11/09/93
PRC 3414
Plummer
Meier

APPROVAL OF THE RENEWAL TERMS OF
A GENERAL LEASE-INDUSTRIAL USE FOR
A MARINE TERMINAL AND APPURTENANT PIPELINES

**ATTACHMENT
RESPONSE TO STATE LANDS COMMISSION
MARINE VAPOR RECOVERY (MVR) COMMENTS**

CALCULATION COVER SHEET

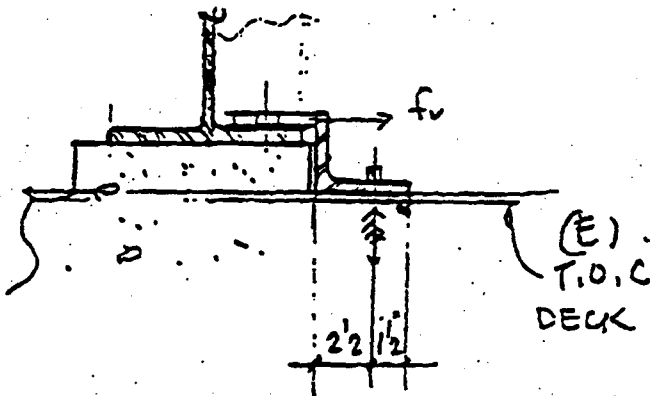
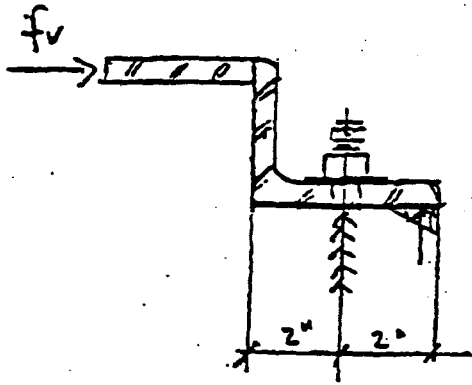
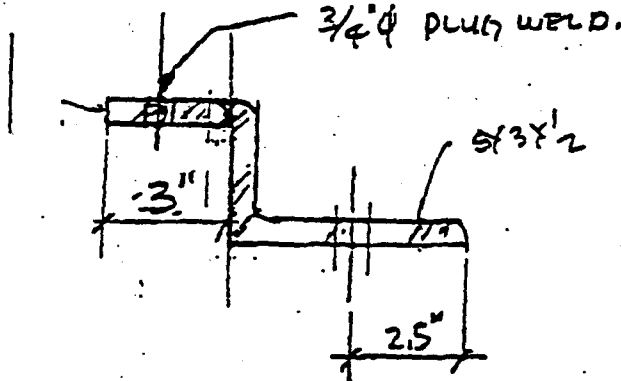
$$\Sigma f/B = \frac{6.8}{6.8} + \frac{14.25}{5.72} = 1 + 2.49 = 3.49 >> 1.33 \text{ N.G.}$$

$$f_c = \frac{2 \times 10680}{8.5 \times 0.25 \times 3} = 3350 \text{ psi} > 0.7 f_c' \times 1.33 = 0.93 f_c' = 2332$$

$$f_c = \frac{10680 \times 1.7 \times 1.1 \times 0.75}{8.5 \times 0.248 \times 2} = 3552 \text{ psi} > 0.7 f_c'$$

b). REVISED BOLT LOCATION AND ADHESIVE TYPE:

CHANGE $d = 2.375$

b) d. CHANGE L to 3x5x1/2

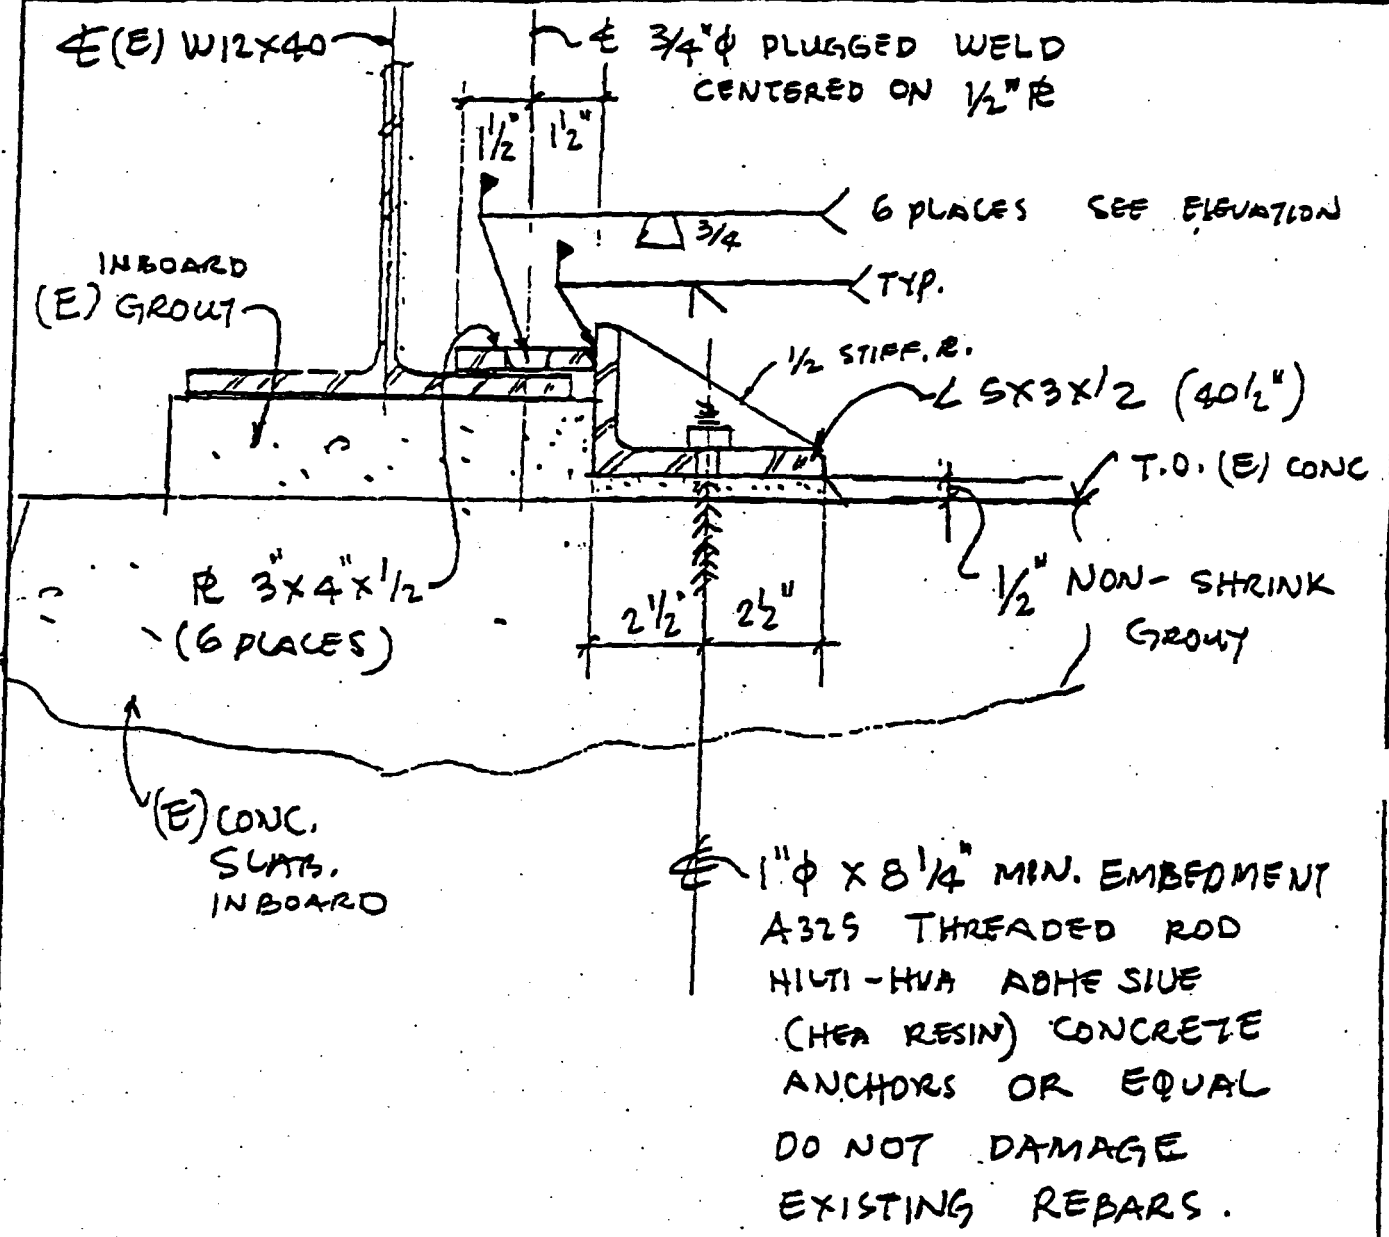
Scheme A: Clips in 5 locations on the inboard side, with 3 studs in each clip. This could go on the inside or outside of the curb, and if outside, could be grouted over to prevent tripping hazards.

Scheme B: Similar to Scheme A, except it does not take all of the shear out on one side. Although the numbers work for clips on one side, it may be preferable to include brackets at the larger curb side also.

Scheme C: Create shear keys by filling in open sections of the skid with reinforced concrete. Drill dowels into the existing deck to tie the shear keys to the deck.

Scheme D: A bolted base plate with attached steel acting as a shear key, again installed in open sections of the skid.

You can call Tony Hitchings at (415) 989-2000 if you have any questions. We are assuming a 1.0g load (136 kips total). We also assume the existing configuration is adequate to resist any overturning. I will try to call State Lands Commission on Monday to confirm their acceptance of the loads.

SHEAR CONNECTOR
INSTALLATION PLAN
MVR SKID
PACIFIC RESTORING.

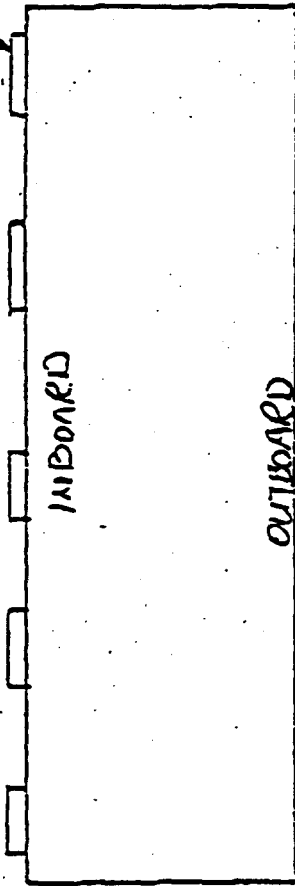
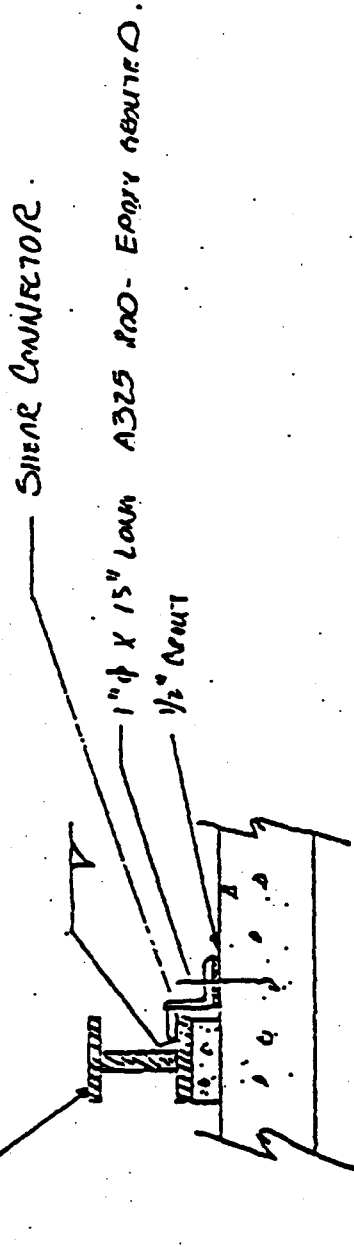
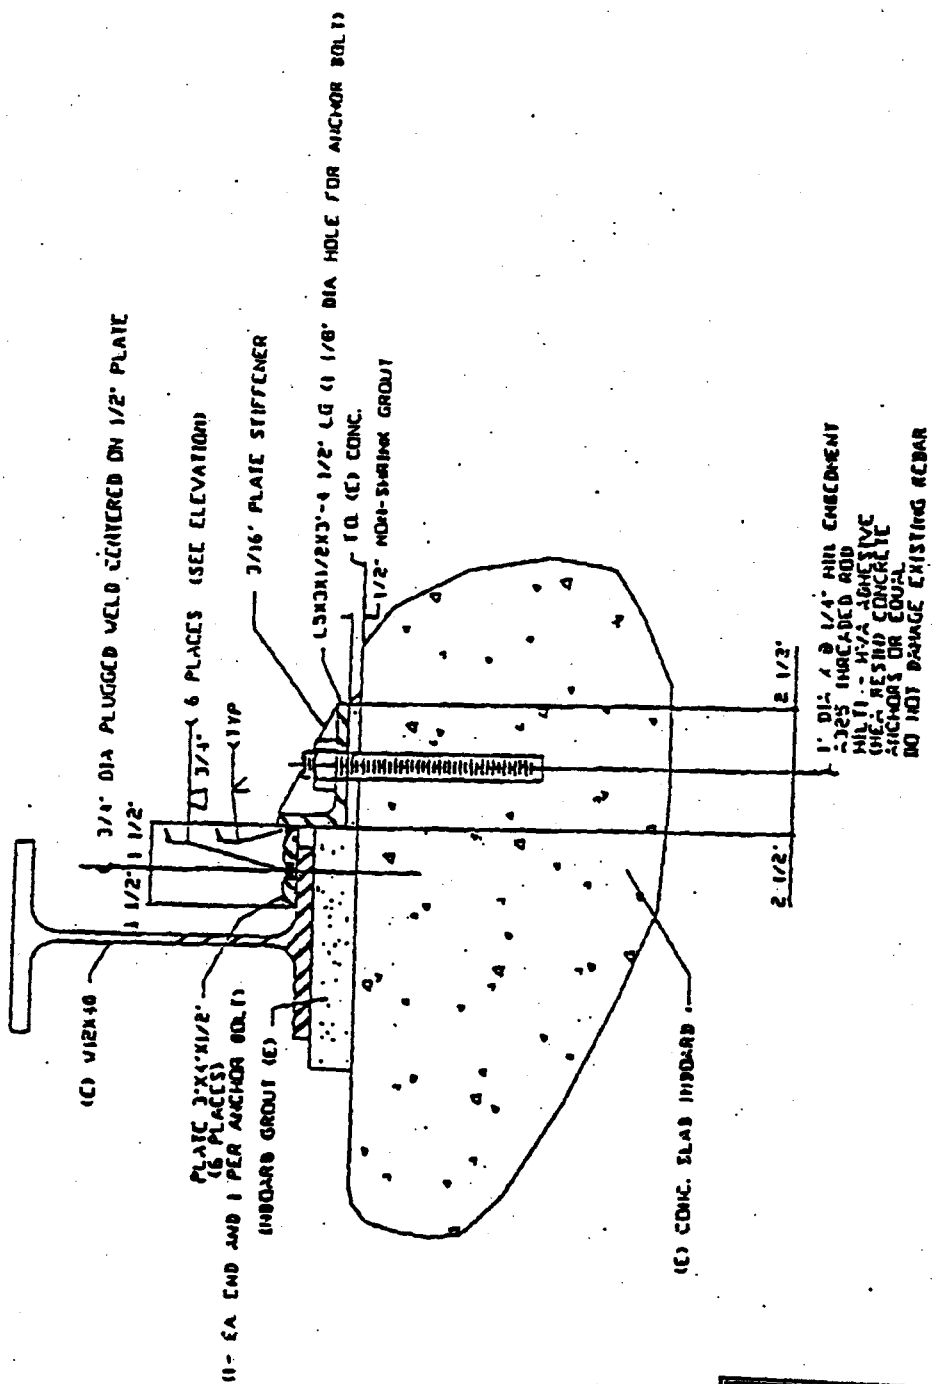
- 1. Justification and explanation of the 1.0 G lateral force.
 - 2. The calculations and proposed design of the "specialized lateral shear connectors".

- 1. Justification and explanation of the 1.0 G lateral force.
 - 2. The calculations and proposed design of the "specialized lateral shear connectors".
